Sydney Modern, Modification 4

Landscape design amendments
State Significant Development Modification Assessment
(SSD 6471 MOD 4)

May 2021

Published by the NSW Department of Planning, Industry and Environment

Figure 3 | Plan illustrating proposed landscape design (top) and approved landscape design (bottom) (Base source: Proposed landscape plan and approved landscape plan)

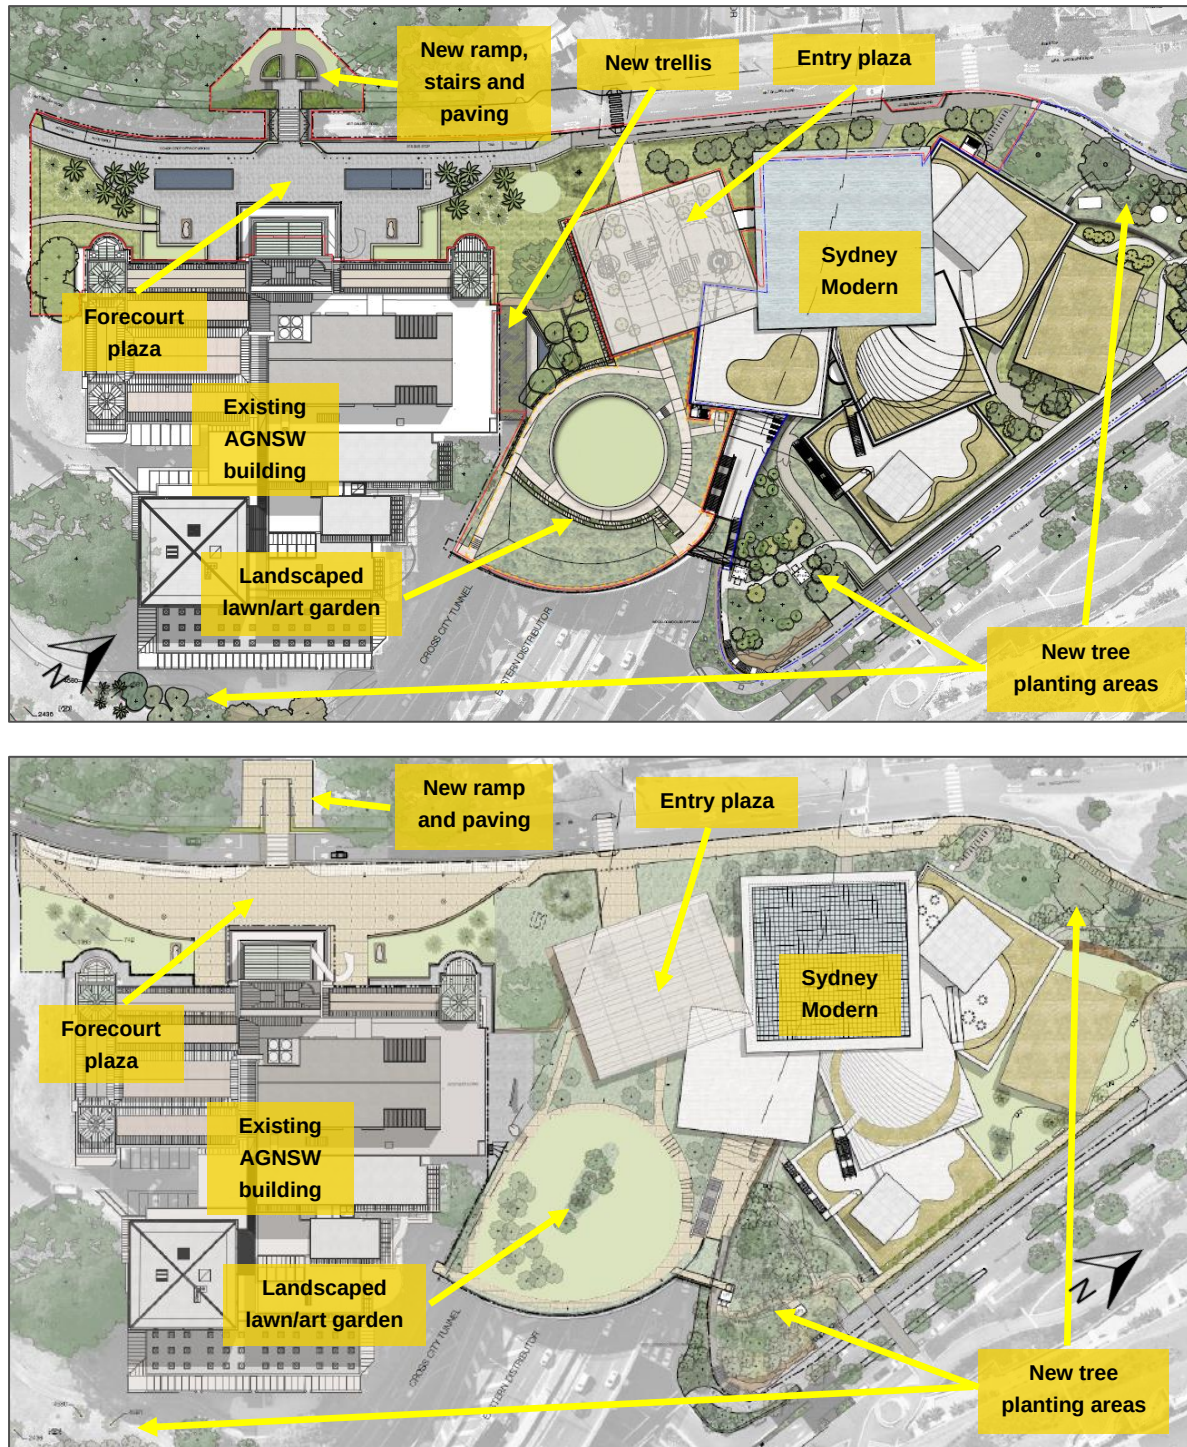
within the forecourt plaza, entry plaza and to the south-east of the existing gallery building (Figure 3). • The modification proposes 25 additional trees resulting in the planting of a total of 298 trees. • The Applicant contends the proposed planting will be predominantly native endemic species. Landscaping will be designed with input from Indigenous communities and the Royal Botanic Garden and Domain Trust. • EESG consider the proposed modification would be unlikely to increase the impact of the development on biodiversity values. • The Department considers the proposed increase in the number of trees to be planted from 273 to 298 satisfies the intent of Condition E19 and will result in an improved and acceptable landscaped and biodiversity outcome. • The proposed revised tree planting scheme and amendment to Condition E19 is therefore supported.	E19 to reflect the increased minimum number of trees to be planted from 273 to 298.

Figure 4 | Modified landscape design of forecourt plaza (Base source: RTS proposed landscape plan)

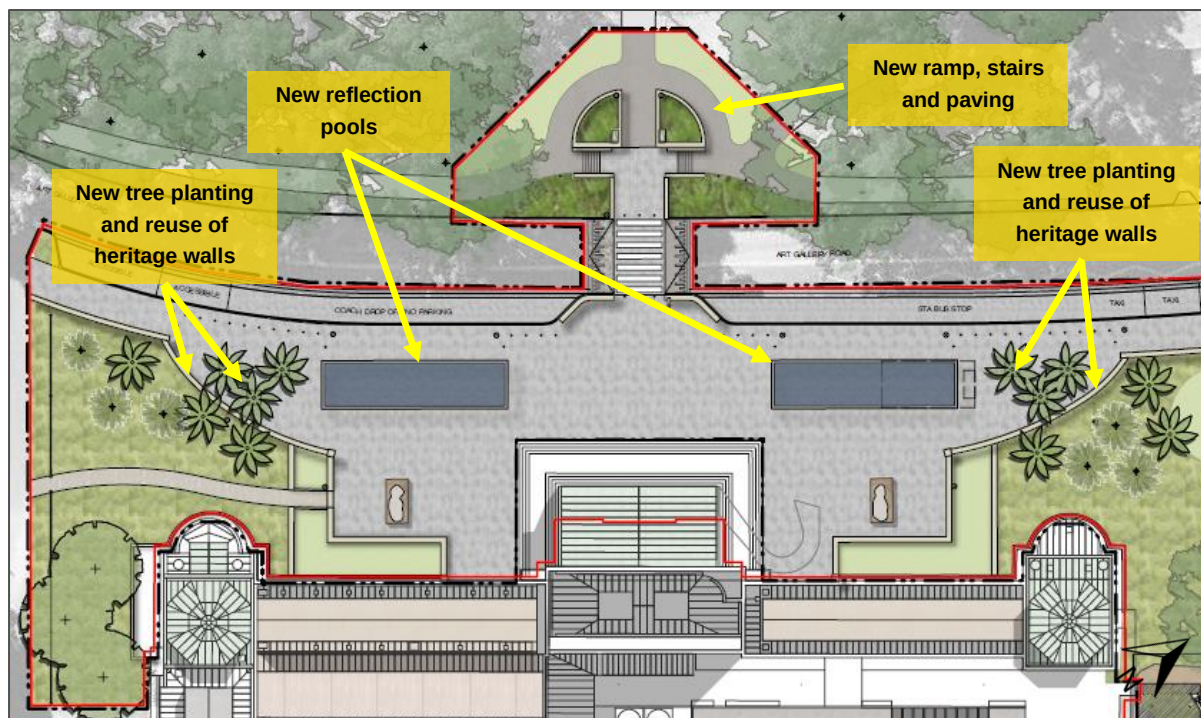
In response to the RTS, Council recommended the proposed bollards be realigned and that a new condition be imposed requiring the final form, materiality and spacing of the bollards be approved by Council. In addition, Council recommended that six of the proposed 12 Cabbage Palms revert to the originally proposed Red Bloodwoods to increase canopy cover.

NSW Heritage (Heritage Council) advised that the height and size of the proposed reflection pools should be reduced as much as possible to minimise any visual impact on the existing gallery building. In addition, although the proposed palm trees are less dense than originally proposed, NSW Heritage advised that concerns remain that the new trees may impact views to the existing gallery building.

The public submission suggested a number of further improvements could be made to the design of the forecourt plaza, including the location and design of the stone walls, reflection pools and bollards.

The Applicant contends the proposed design modifications to the forecourt plaza incorporate the specific design of landscape architect Kathryn Gustafson while maintaining the broader landscape design of the approved development. This includes elements such as the reconstruction of the serpentine dwarf walls and improvements associated with the removal of the existing car parking area.

The Applicant further contends the height of the reflection pools cannot be reduced as they form part of the integrated hostile vehicle security measures and their height and size help achieve this. The Applicant's RTS Heritage Impact Statement (HIS) noted details regarding hostile vehicle management measures however these should be confirmed in detailed design development with heritage advice.

- they have been subject to detailed review by the DIP and are consistent with the recommendations and views of the DIP, which advised the proposed reflection pools are a positive addition to the forecourt plaza
- they would significantly enhance the original approved landscape design whilst retaining the predominantly open nature of the approved plaza
- the area around the proposed reflection pools has been increased to allow additional space and clearances and that the height (maximum of 675 mm) and size of the pools are necessary for the pools to form a hostile vehicle security function

- they would provide an attractive feature within the forecourt that would not detract from the views of the existing gallery building.

In addition, the Department recommends an amendment to Condition B20 (New Steps, Ramp and Pedestrian Control Structures) to specifically include a review and endorsement role for NSW Heritage regarding the design details of hostile vehicle management measures and also a consultation role for Council regarding the final form, materiality and spacing of bollards.

The Department considers the proposed 12 palm trees are acceptable as they have been located to either side of forecourt plaza and are a narrow trunk species that will minimise any view impacts to the existing gallery building. In addition, the trees will enhance the landscaped appearance of the site within the Domain and will still provide areas of shade within the forecourt for visitors.

Figure 5 | Modified landscape design of Entry Plaza (Base source: RTS proposed landscape plans)

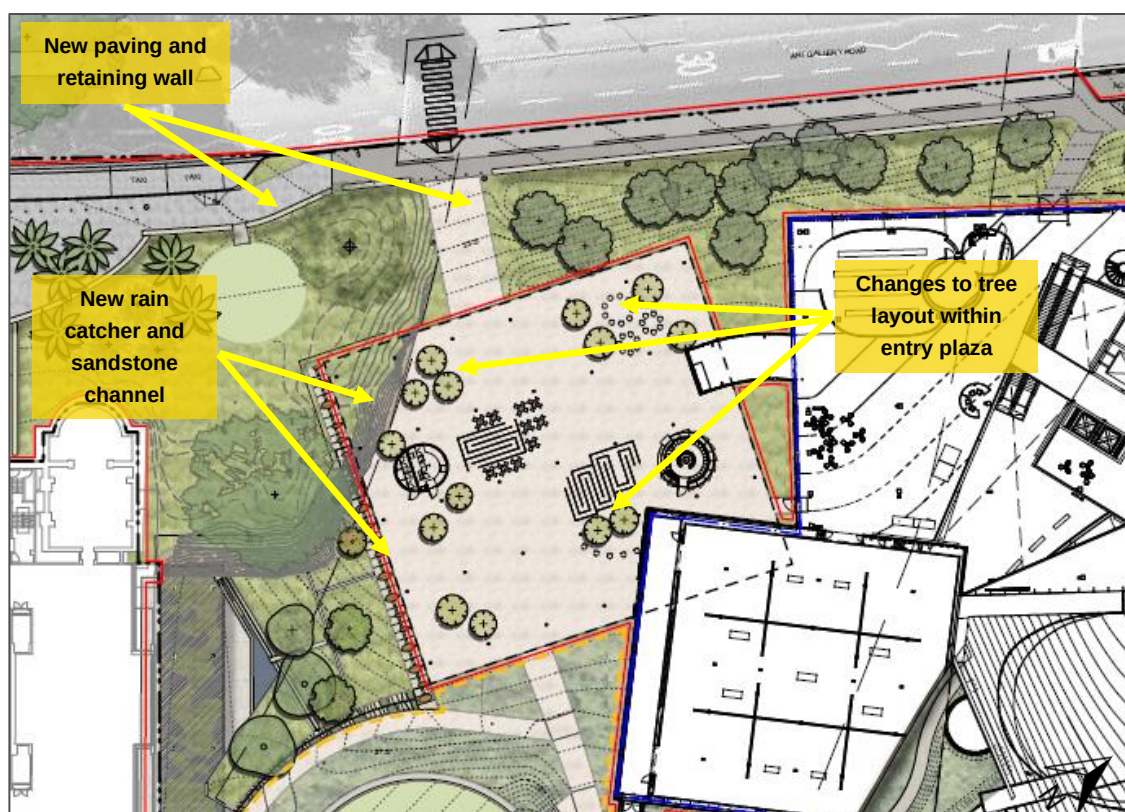
Council commented that the new potted trees located beneath the entry plaza canopy are unlikely to reach maturity. NSW Heritage (Heritage Council) have raised no concerns in response to the RTS.

The Applicant contends the proposed changes to paving and retaining walls are consistent with the original design intent and will improve the relationship between the existing and approved buildings. The new rain catcher and associated sandstone channel have been designed to sit comfortably within the landscape and would have a neutral impact on the overall stormwater design.

The Applicant also contends it is necessary for the trees in the entry plaza to change to trees planted in pots as this will allow flexibility in the use of the space, to accommodate artworks as well as changes in visitor behaviour and events, as the trees will be able to be moved around. In addition, given the

- the amendment from trees planted in the ground to trees planted in pots would allow the trees to be relocated if required to suit the microclimates and preferred conditions for different species. The visual outcome would also remain consistent with the approved landscaped scheme beneath the canopy

- the entry plaza has been subject to detailed review by the DIP and is consistent with the recommendations of the DIP who support the proposed rain catcher and channel, trees and design/ambiance of the space

- the landscape design of the entry plaza provides greater detail and will significantly enhance the original approved landscape design whilst maintaining a predominantly open and landscaped entry plaza to the new gallery building

- Condition E19 is recommended to be amended to require the 14 trees located in pots to be retained beneath the canopy. This will ensure the visual outcome would remain consistent with the approved landscaped scheme.

Figure 6 | Modified landscape design of landscaped lawn/art garden. New artwork commission area shown bounded in green (Base source: RTS proposed landscape plans)

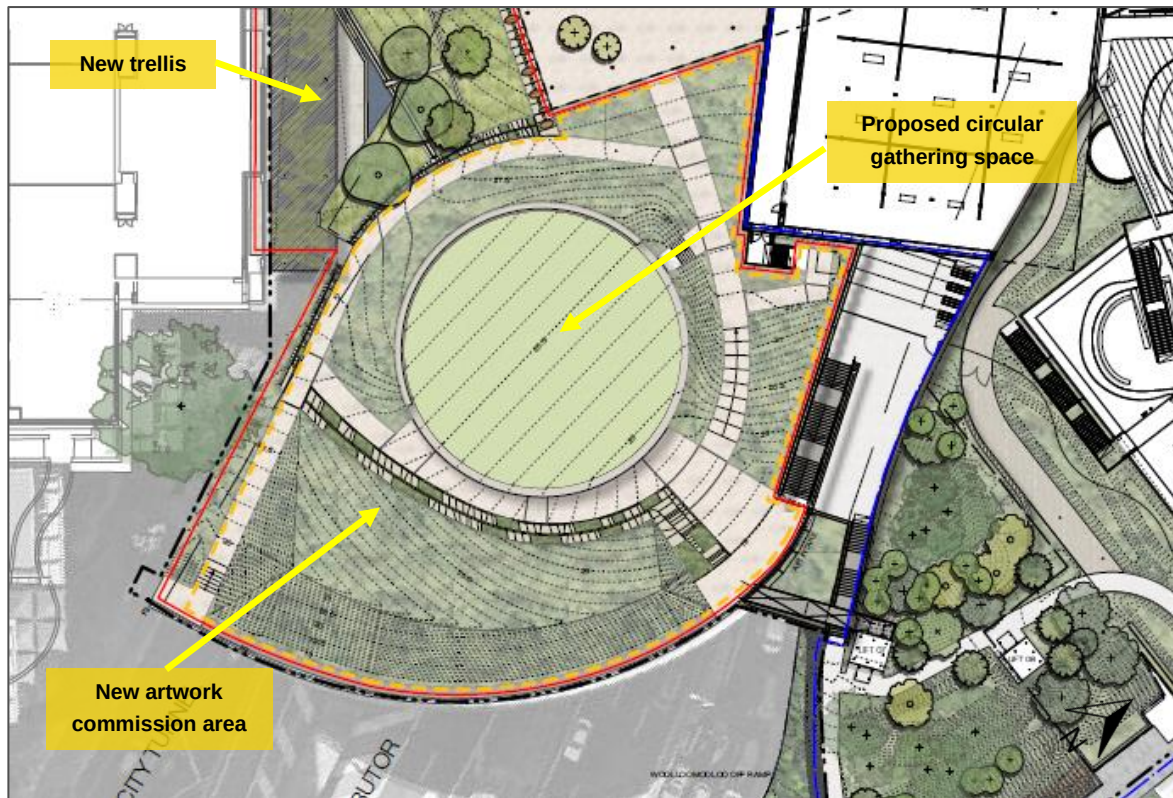
In response to the RTS, Council requested a new condition be imposed to ensure the new artwork commission contains sufficient tree canopy cover.

NSW Heritage (Heritage Council) requested the design of the proposed landscaping on the land bridge should be subject to further detailed heritage review to ensure the landscape reflects the aesthetics of the RBG. In addition, it was requested that the detailed design of the trellis be subject to further heritage consultation. These matters are considered separately below.

In response to Council's comments, the Applicant proposes a new condition in relation to the planting size of proposed new tree planting within the art commission area (incorporated as part of proposed Condition D30). However, the Applicant contends the species selection and mature heights are limited by the loading constraints of the land bridge and Council's recommended minimum pot size of 200 litres and height of two metres at planting will depend on availability of stock.

- Condition D30 is recommended requiring the final landscape design for the art commission area, including the planting of a minimum of 26 native trees, to be prepared in consultation with NSW Heritage, TfNSW and Transurban, and to be submitted to the Planning Secretary for approval
